Revised STAFF REPORT AND RECOMMENDATION TO THE DESIGN COMMISSION – Approval

CASE FILE: LU 15-259840 DZM
PC # 15-177695
1111 SE Sandy Blvd
REVIEW BY: Design Commission
WHEN: April 14, 2016, 1:30pm
WHERE: 1900 SW Fourth Ave., Room 2500A
Portland, OR 97201

C09

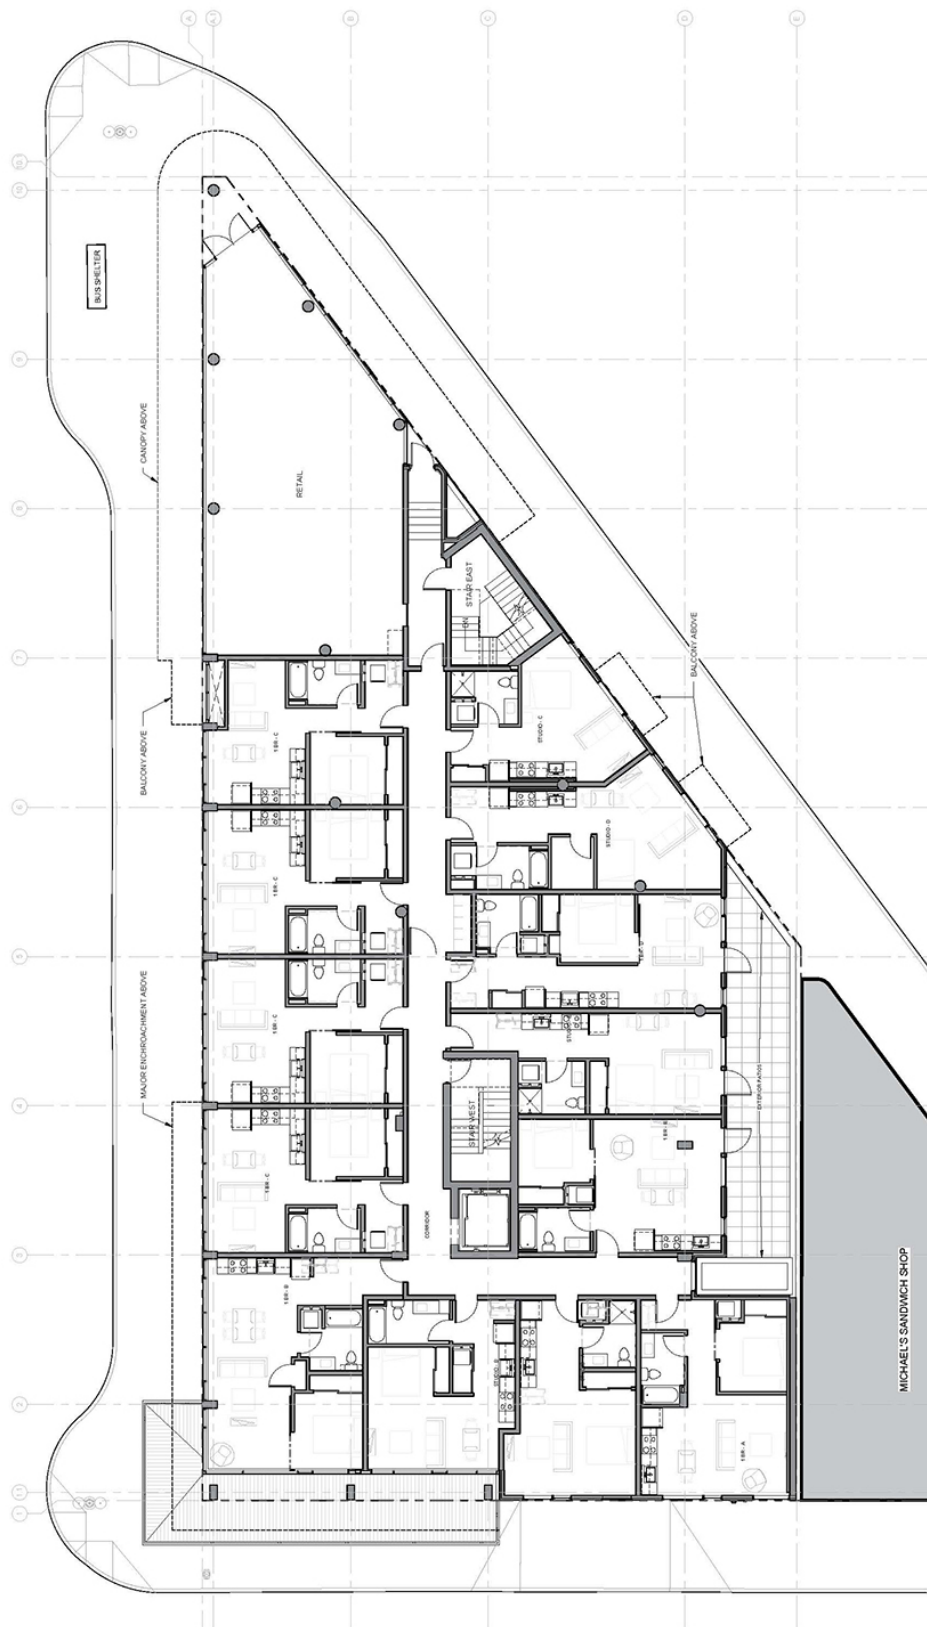
Findings for Modification 1: The applicant proposes one on-site loading space within the at-grade parking garage intended to serve truck loading demands associated with apartment move-in/outs. The entrance to the parking garage will be provided by a 20-foot wide driveway along SE 11th Ave, approximately 60 feet south of the extended curb line on E Burnside St. The entrance will include a sectional security gate located 12 feet from the finished curb line.

Loading movements will be forward ingress and back-out egress. A queuing analysis prepared by the applicant's representative (Kittelson and Associates) indicates that there will be sufficient stopping sight distance available for drivers traveling southbound on SE 11th Avenue to stop before reaching a single-unit truck backing out from the proposed site access driveway. In addition, drivers of single-unit trucks (26 feet in length or less) will be able to see if vehicles or bicyclists are present along SE 11th Avenue before attempting a backing maneuver onto the

- A. ***The resulting development will better meet the applicable design guidelines.*** The proposed development better meets the applicable design guidelines (B2 Protect the Pedestrian, C1-1 Integrated Parking) by enhancing pedestrian convenience and safety through consolidating vehicle ingress/egress, parking and loading and internal garage access. The high speed of the garage door operations (1-7 seconds) and perforated metal combine to enhance pedestrian safety and building security – allowing a resident to open the garage door quickly without straddling the sidewalk and view pedestrians on either side of the door and proceed cautiously. Finally, the door closes quickly upon a car pulling into the garage and alleviates a significant security concern of intruders sneaking in through a garage door after a vehicle exits the garage.
